# Economic and Social Council

#### Working Party on Lighting and Light-Signalling

## Report of the Working Party on Lighting and Light-Signalling on its sixty-seventh session

Figure 1

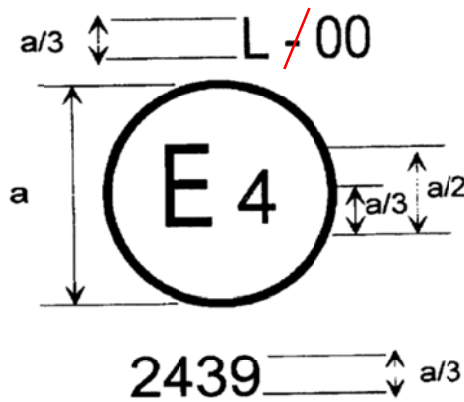
Annex 1, Figure 1, amend to read:

Figure 1

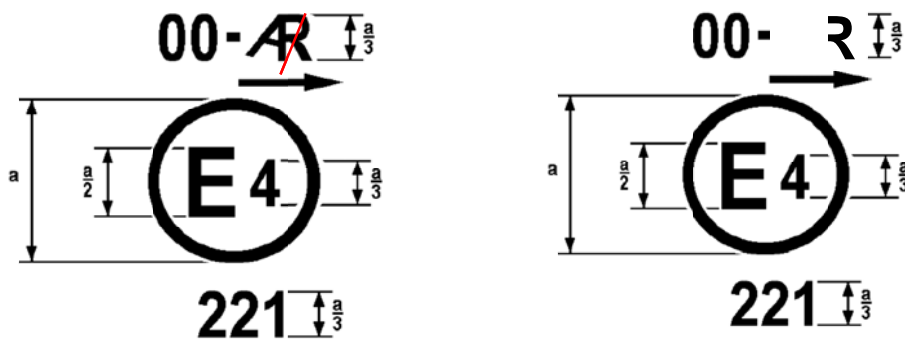
Annex 2, Figure 1, amend to read:

"4.7. Annex 2 gives examples of approval marks for a single lamp (Figure 1) and for grouped, combined or reciprocally incorporated lamps (Figure 2) with all the additional symbols referred to above. ~~in which the letters A and R or M and L are mingled.~~ **The letters A and R may be mingled.**"

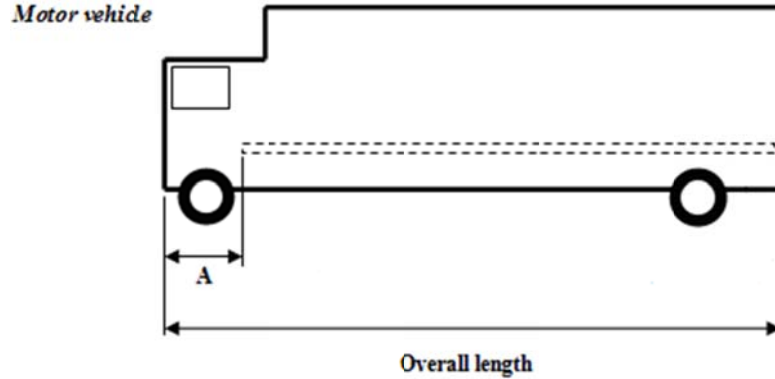
6.21.4.2.1. The conspicuity marking shall be as close as practicable to the ends of the vehicle and reach to within 600 mm of each end of the vehicle (~~or cab in the case of tractor units for semi-trailers~~).

6.21.4.2.1.1. for motor vehicles, each end of the vehicle, or in the case of tractors for semi-trailers each end of the cab;

**however, an alternative marking mode within 2400 mm from the front end of the motor vehicle is allowed where a series of retro-reflectors of Class IVA of Regulation No. 3 or Class C of Regulation No. 104 are mounted followed by the required conspicuity marking as follows:**

- **Retro-reflector size minimum 25 cm<sup>2</sup>;**
- **One retro-reflector mounted not more than 600 mm from the front end of the vehicle;**
- **Additional retro-reflectors spaced not more than 600 mm apart;**
- **The distance between the last retro-reflector and the start of the conspicuity marking shall not exceed 600 mm;**

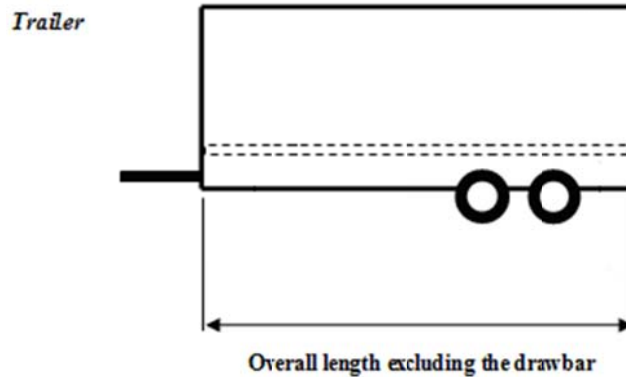
Paragraph 6.21.4.2.2., amend to read:

"6.21.4.2.2.2. For trailers, the **overall** length of the vehicle (excluding the drawbar).

#### MINIMUM HORIZONTAL (H) AND MINIMUM VERTICAL (V) ANGLES FOR SPATIAL LIGHT DISTRIBUTION

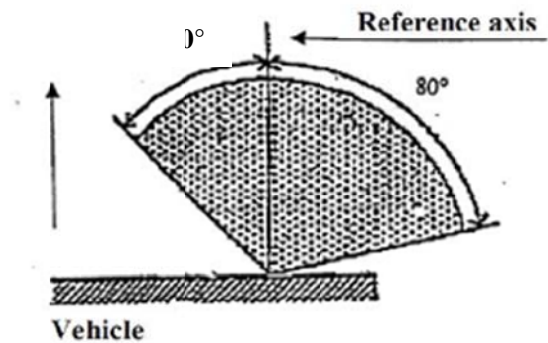
#### "ANNEX 1
